TYPE III – HISTORIC REVIEW STAFF REPORT AND RECOMMENDATION

FILE NO.: GLUA-20-00001 and HR 19-06: Modification to HR 18-09 Historic Review for a

new single family home in the Canemah Historic District.

LOCATION: 704 3rd Avenue

Images of house:

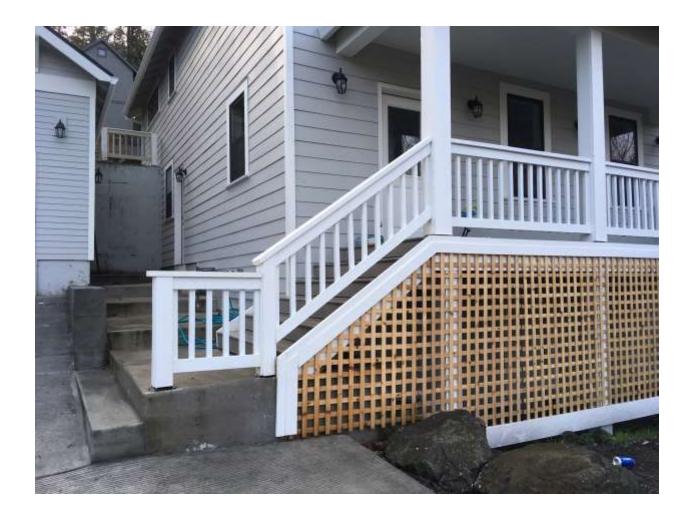
The constructed home contains a side stair to the front porch, with 8 steps total. The total height is greater than 5 feet from grade, but an exact measurement has not been provided.

Some of the porch decking material and front stairs material used is modern composite decking material that was not approved as a building material for this structures.

The applicant was required to return to the Board for approval if the number of stair risers were to exceed six. The building plans for issuance of the building permit showed five risers. The final result, now that the home is almost finished, is 8 risers.

In this particular case, the material is used on the front porch decking and stair and is neither highly visible nor a primary building material for the structure. Additionally, staff finds that the material is similar in appearance to painted wood. For these reasons, staff finds that it will not have a significant detrimental impact on neighboring properties or on the historic character of the Canemah district.

Staff finds that the impact of the stair is not significant when viewed from the street. The sloping lot means that the home is greatly elevated from the street level, and because the home projects in front of

the garage, the stairs are needed to reach the front porch. Staff finds that the final stair height is acceptable.
